**CERTIFICATE OF APPROPRIATENESS**

**Property:** 528 Highland Street, Lot 8 & Tract 7, Block 20, Woodland Heights Subdivision. The property includes a historic one-story residence situated on a 7,500 square foot (75' x 100') corner lot.

**Proposal:** Alteration – Request for HAHC approval of completed and partially completed alterations that have exceeded the scope of work approved in two previous COAs.

### WEST SIDE ELEVATION (FACING NORTHWOOD STREET)

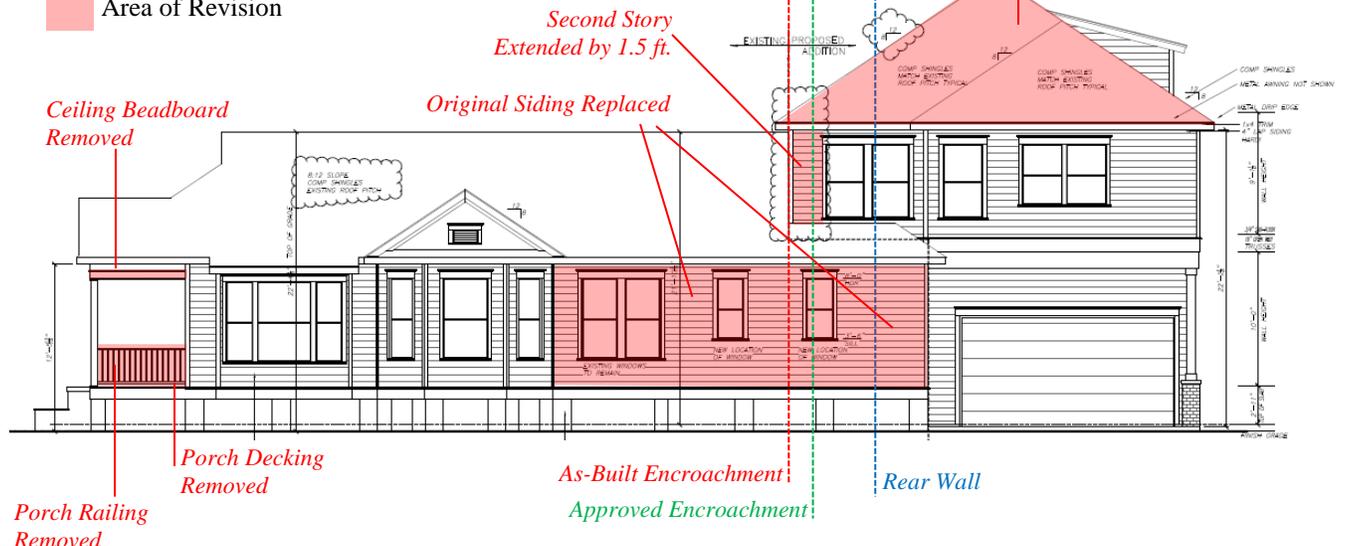
*Roof Pitch Altered and Ridge Height Increased by 2'*

- Structure taller than approved. Due to the increase in roof pitch, the actual ridge of the addition is 2'-1" taller than approved. The approved ridge height was 30'-5" while the structure currently has a height of 32'-6".

- Incorrect roof pitches. Plans note that existing roof pitch is 6:12 and that the proposed addition roof was to match existing at 6:12. However, the applicant's designer "eyeballed" the existing roof pitch and was incorrect with 6:12. The existing roof pitch is actually 8:12 and therefore, the roof of the addition was built at 8:12 (to match existing) and not at 6:12. If staff was aware of the existing 8:12 roof pitch, staff would have advised that applicant to reduce the roof pitch to 6:12, or lower, in order to reduce the height of the structure.

*Staff recommends that the owner be required to build in accordance with the earlier approved COA, to remove all unapproved work already performed, and to make repairs with in-kind materials.*

EAST SIDE ELEVATION

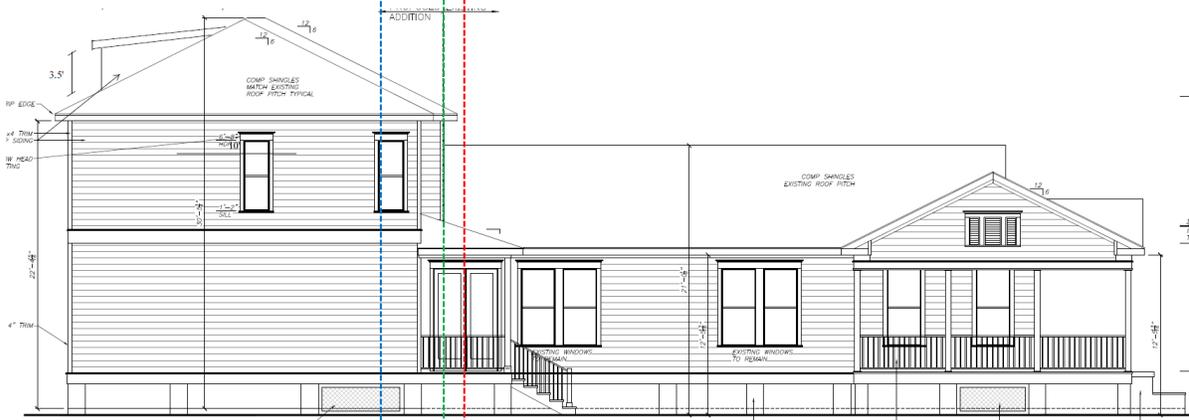
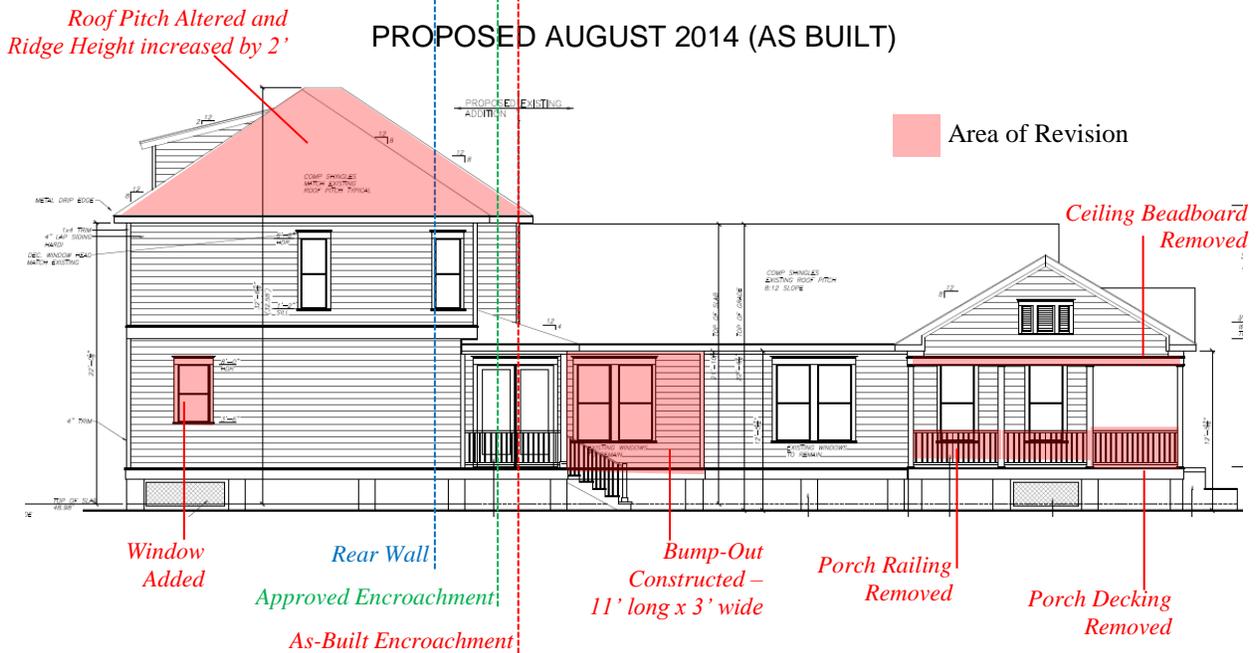
- Bump-out on east elevation. A 2'-10" wide by 10'-9" deep bump-out on the first-story of the original structure was constructed. In order to bump out the existing wall, historic material was destroyed. Fortunately, the original windows from this location, which were removed, were later installed in the bump-out. According to the applicant, the foundation company installed the piers based on the "bid set" of plans which included this portion of the addition. The final COA approved plans did not include this portion. The framer continued on with the error and it was not realized until the framing was complete.

**Windows/Doors:** A 2'-0" x 3'-0" window was added to the bathroom at the very rear of the east side of the residence. According to the applicant, the plans were changed to include this window and the permit runner took them to the city for approval. However, the permit runner did not take the plans to Planning for Historical approval. See drawings and photos for more detail.

**SOUTH (REAR) ELEVATION**

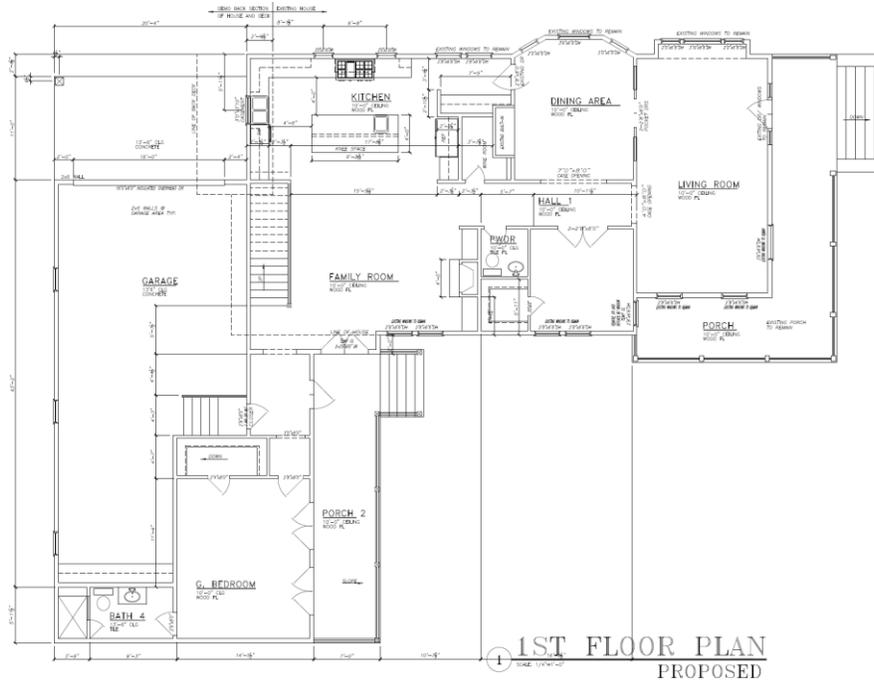
- The second story addition extends 18" farther onto the original house than approved. This encroachment runs for 28' along the front elevation. No explanation of why this happened has been provided.
